■ A750F AUTOMATIC TRANSMISSION

1. ATF WS

259LSK03

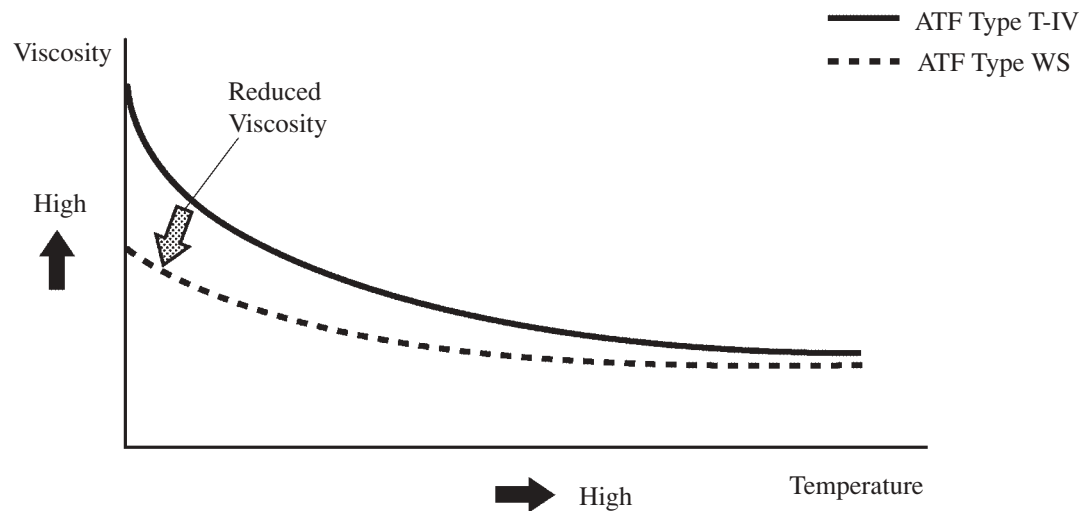
- The T-IV type ATF (Automatic Transmission Fluid) of the A750F automatic transmission on the previous Land Cruiser has been changed to the WS type on the new Land Cruiser. The reduced viscosity in the practical operating temperature range of the ATF WS enables to reduce drag loss and improve fuel economy.
- The ATF WS is not interchangeable with other types of ATF (ATF type T-IV, or D-II).

If a vehicle with a transmission filled with ATF WS is replenished with other type of ATF, the vehicle might not start off at extremely low temperatures. However, it will start off after it has been warmed up for a few minutes.
